SUBJECT: REGION V INPUT TO ACRS REQUESTS ON PALO VERDE

### Review of Startup Experience for Palo Verde Unit 1

SEPTEMBER 12, 1985 EVENT AT PALO VERDE UNIT 1

FIGURE 2.1-4  
SIMPLIFIED SCHEMATIC OF PALO VERDE CVCS SHOWING AUXILIARY  
SPRAY PORTION AND SOURCES OF BORATED WATER

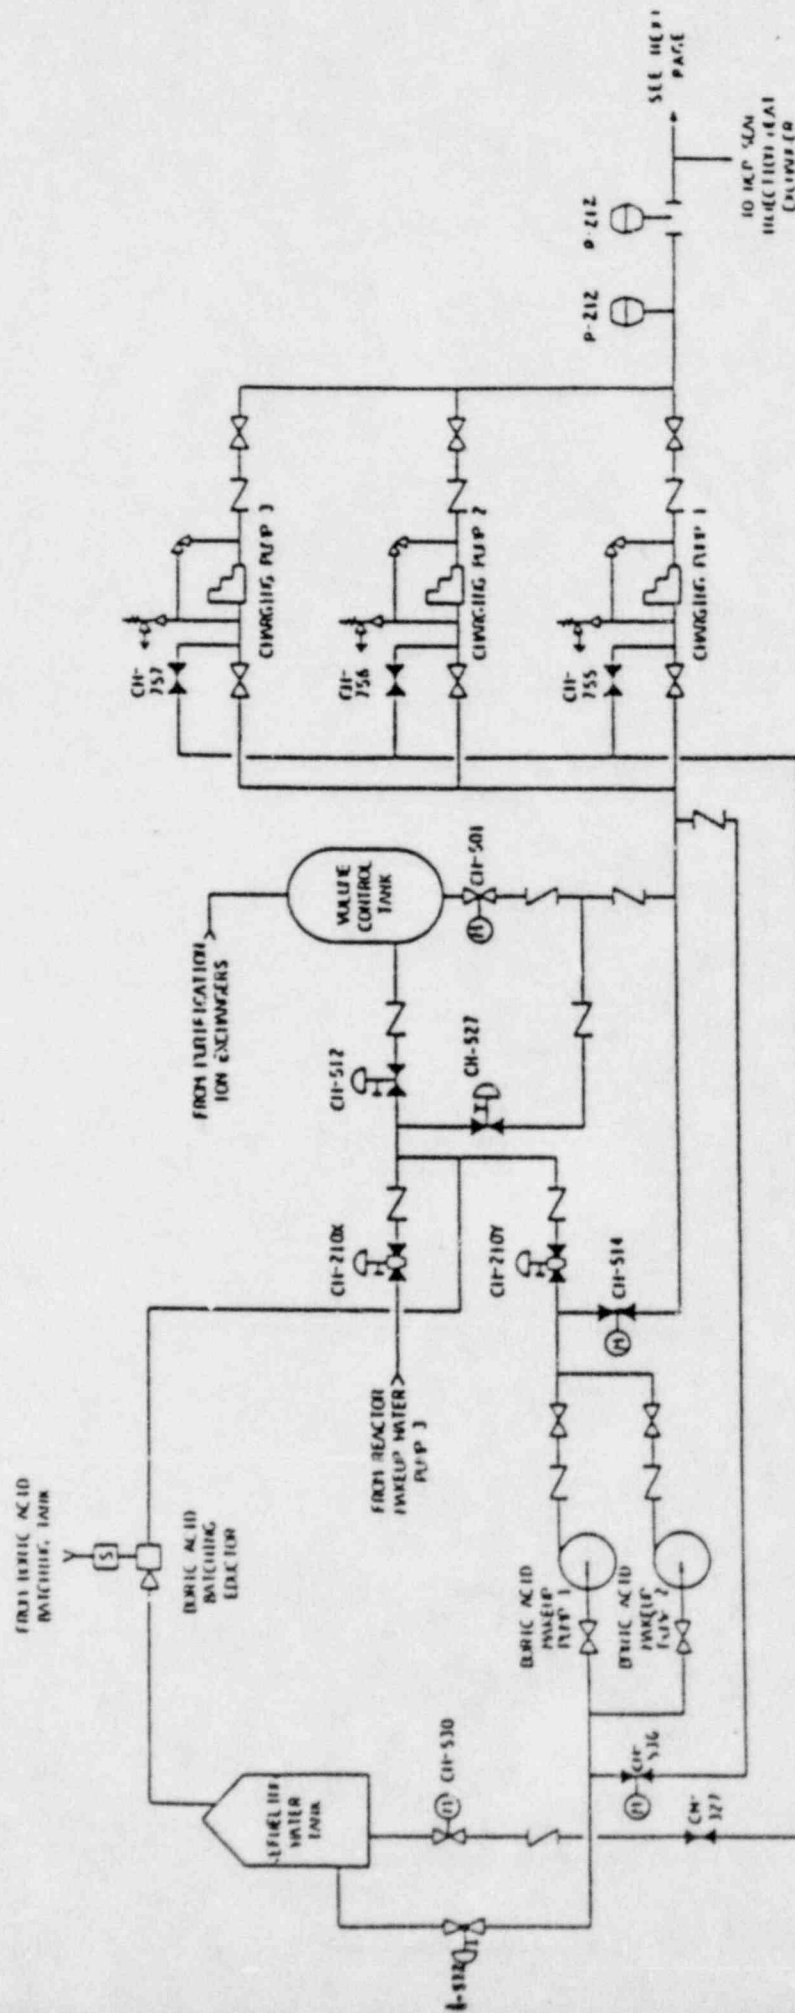
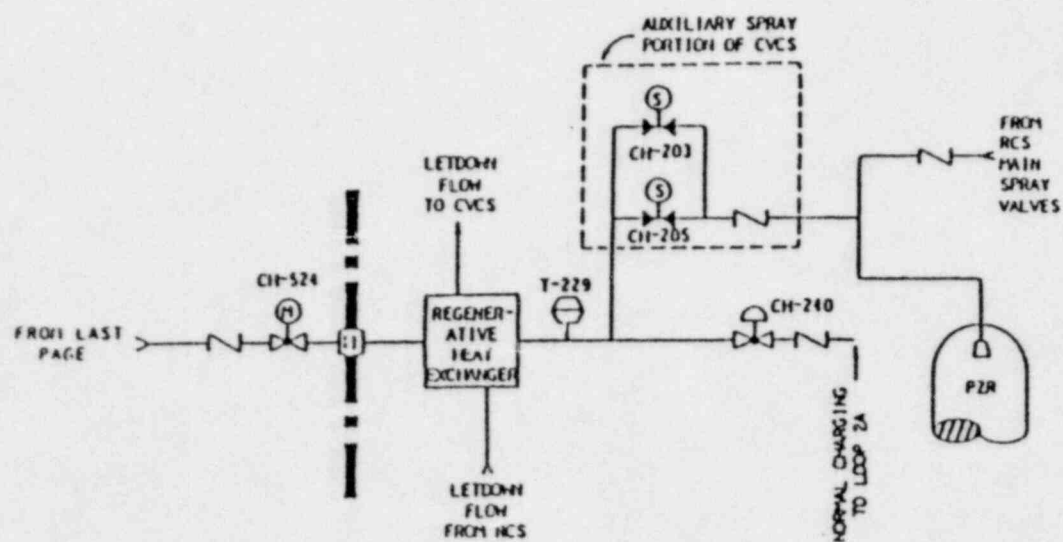
- o AUXILIARY PRESSURIZER SPRAY SYSTEM BEGINS AT BRANCH FROM CHARGING SYSTEM AND ENDS AT PRESSURIZER SPRAY NOZZLES
- o MECHANICAL COMPONENTS CONSIST OF:
  - PIPING
  - TWO SOLENOID OPERATED VALVES (CH-203 & CH-205)
  - CHECK VALVE
- o SCHEMATIC OF AUXILIARY PRESSURIZER SPRAY SYSTEM AND SOURCES OF BORATED WATER (VIA CHARGING SYSTEM) SHOWN IN:
  - FIGURE 2.1-4 OF CEN-239, AND
  - FIGURES 5 & 6 OF APPENDIX B IN NUREG-1044

## CVCS ENHANCEMENT

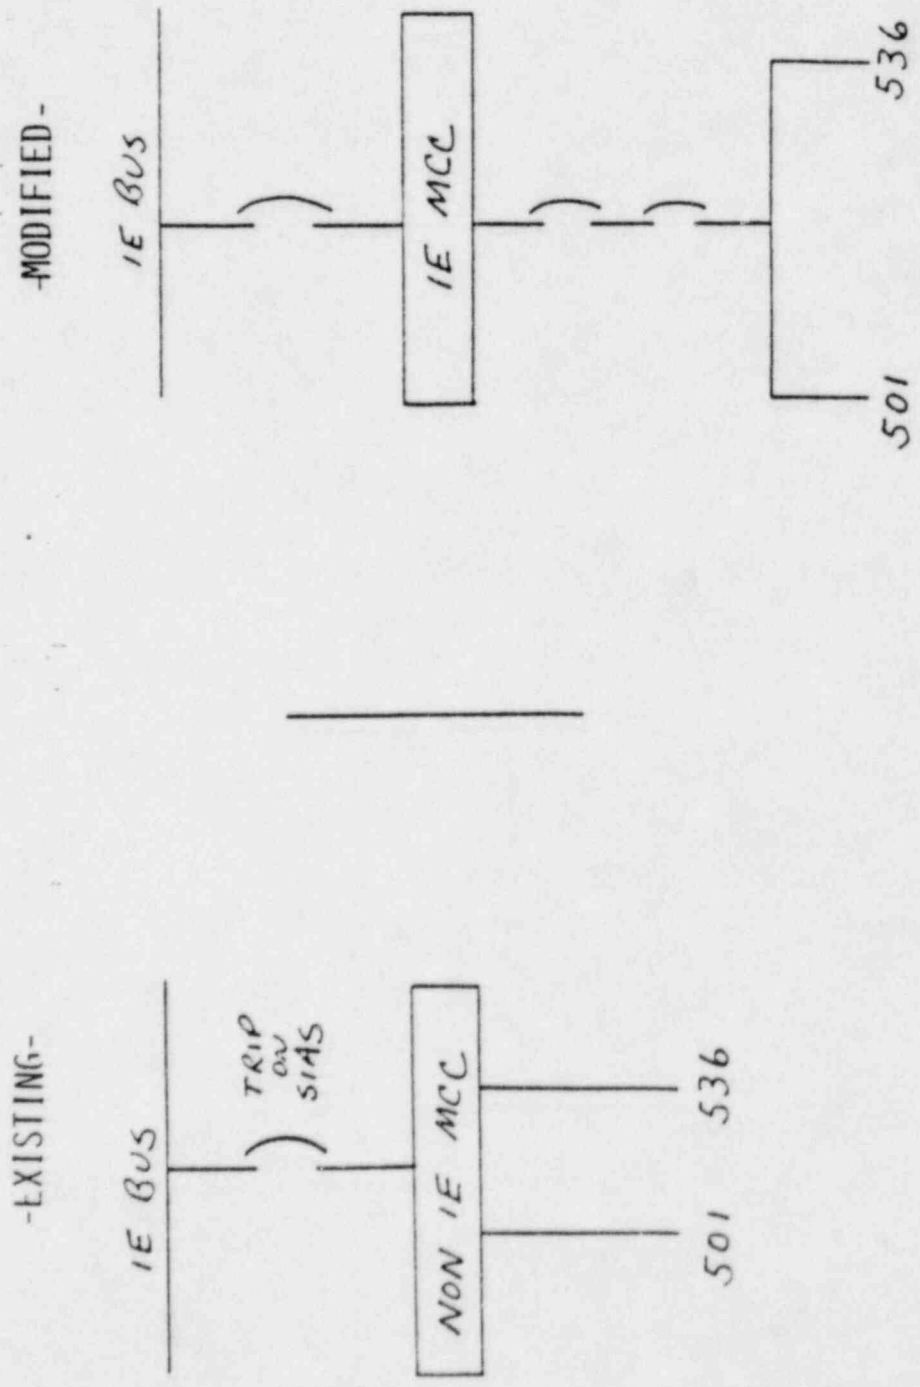
- o REPORT OF ACTIONS UNDERTAKEN TO ADDRESS SEPTEMBER 12, 1985  
EVENT ( PER SEPTEMBER 20, 1985 MEETING )
- o THREE MODIFICATIONS PLANNED
  - ENSURE CONTINUED CONTROL OF V501 AND V536  
FOLLOWING LOP AND SIAS
  - ADD SECOND, DIVERSE REFERENCE LEG FOR VCT  
LEVEL MONITORING WITH ALARM
  - AUTOMATIC REALIGNMENT OF V501 AND V536

# VOLUME CONTROL TANK LEVEL INDICATION

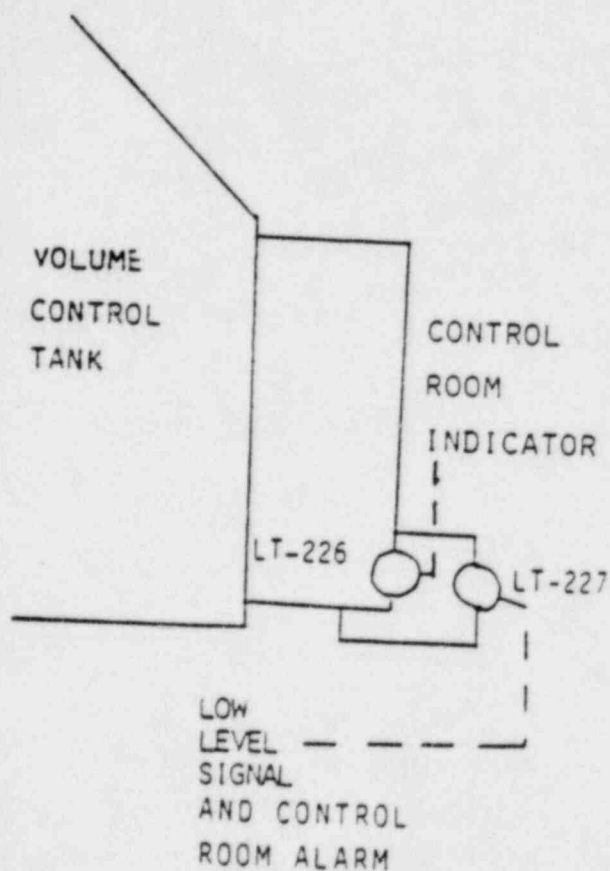
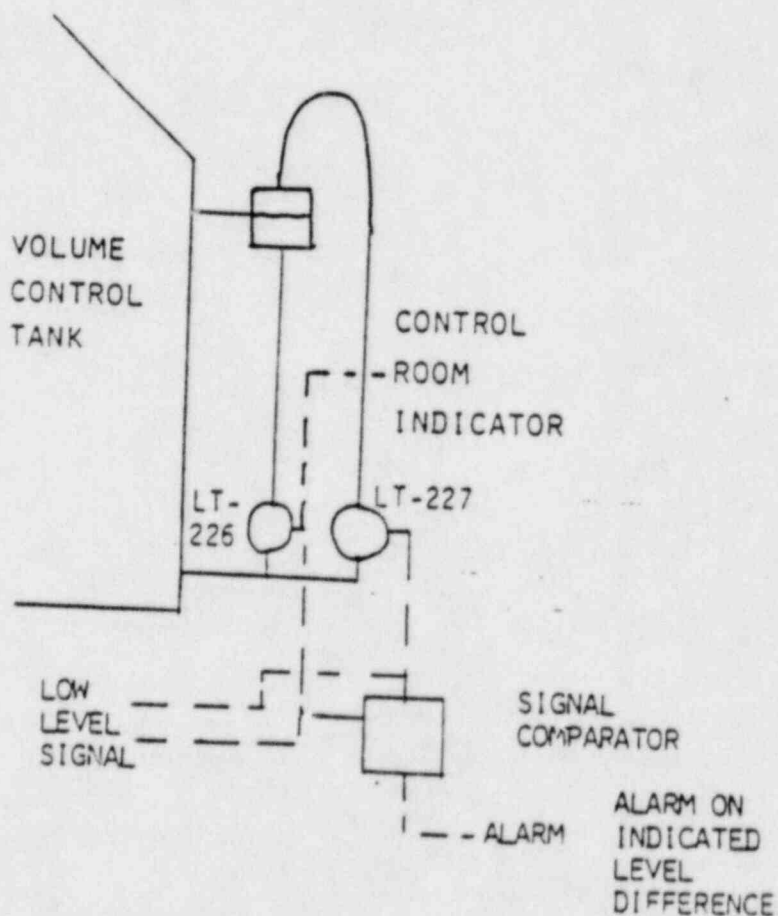
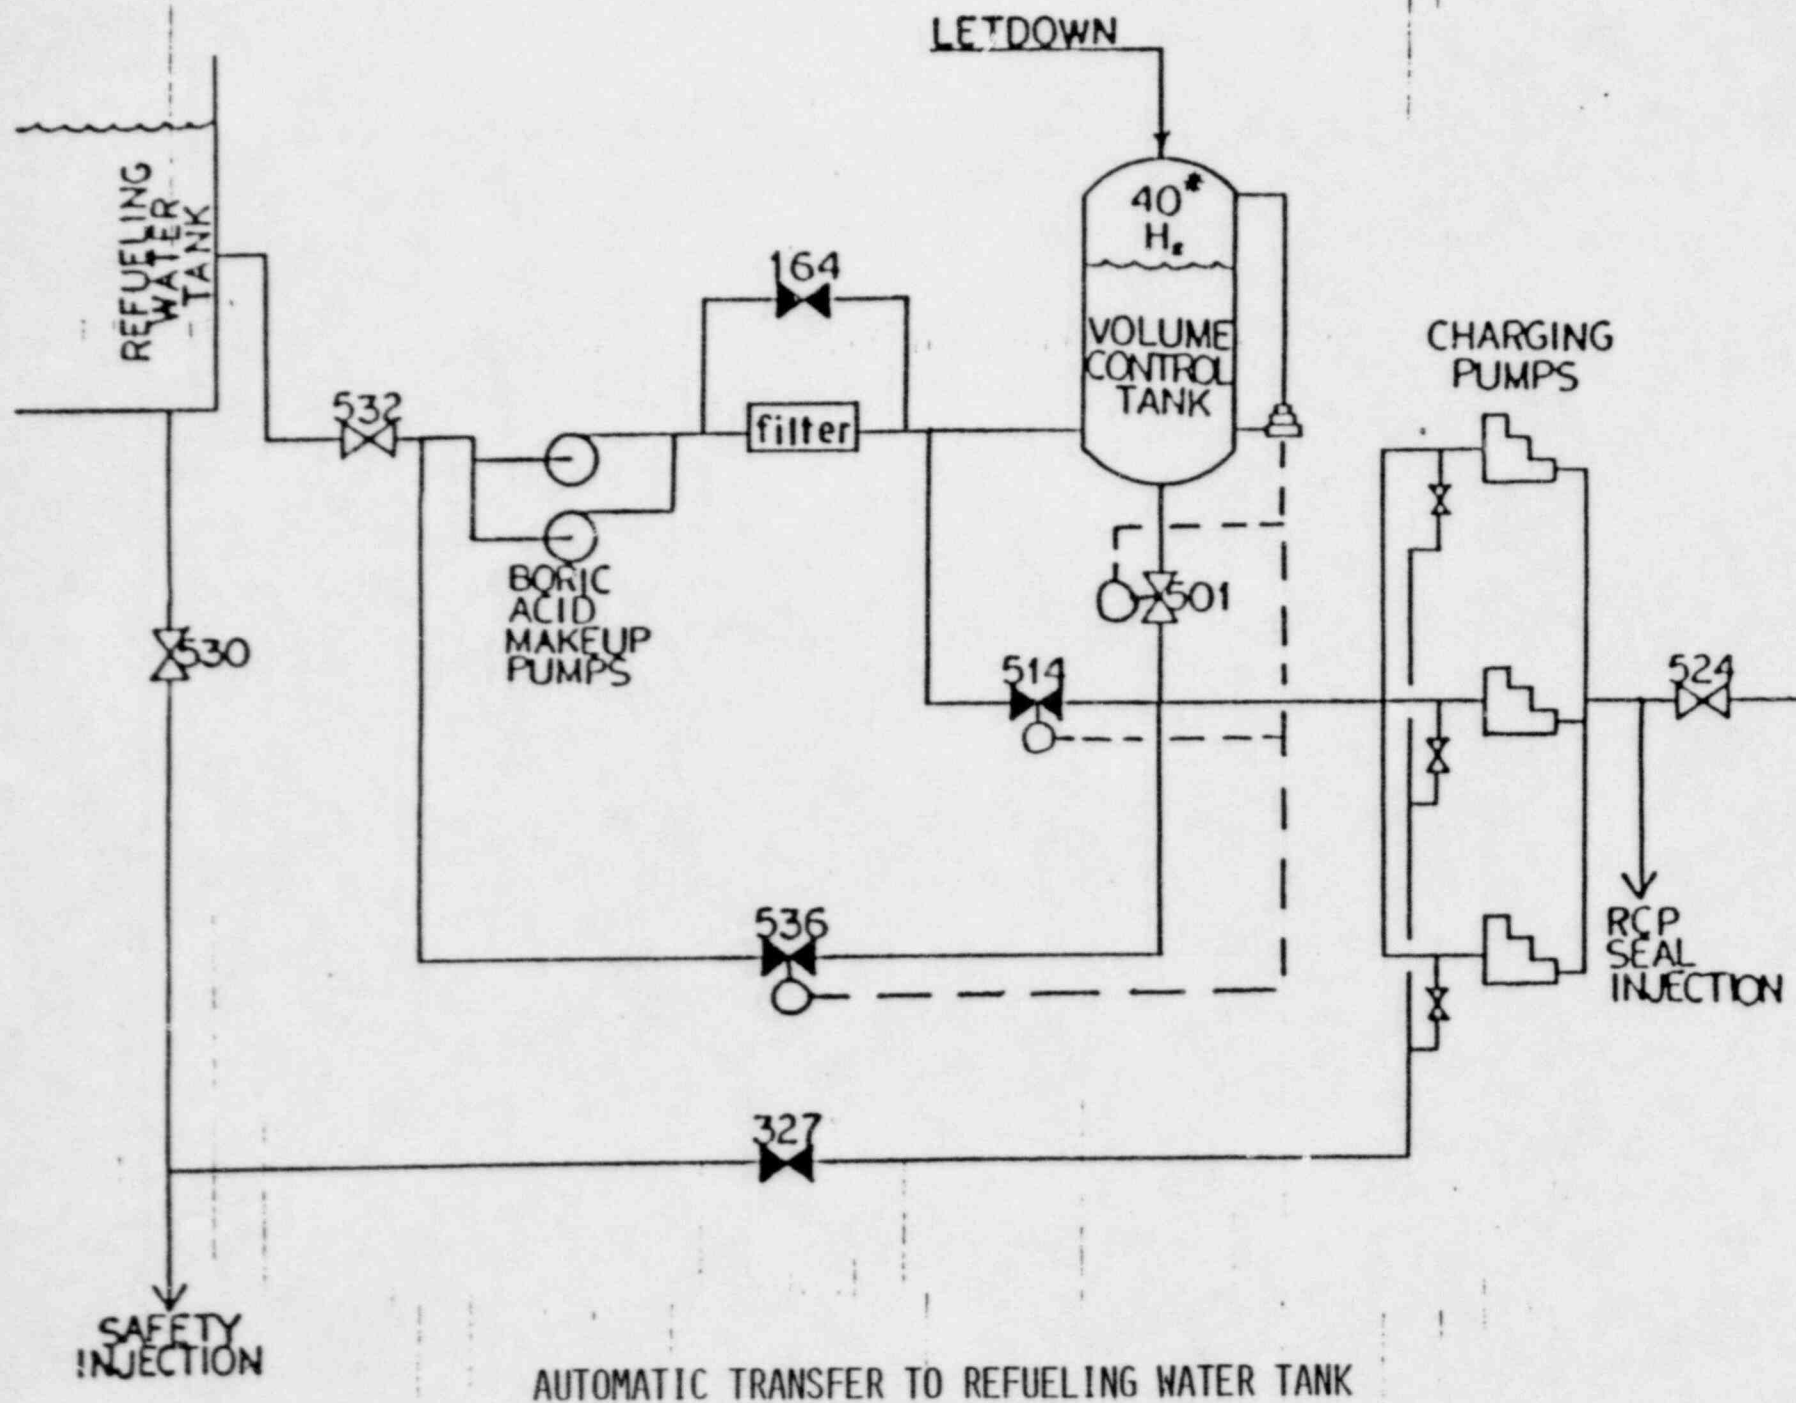
1. SEPERATE REFERENCE LEG TO EACH TRANSMITTER
2. ONE WET AND ONE DRY LEG TO PROVIDE DIVERSE REFERENCE
3. COMPARATOR ALARM PROVIDES INDICATION OF POSSIBLE LOSS OF CORRECT REFERENCE TO ONE OF THE TRANSMITTERS
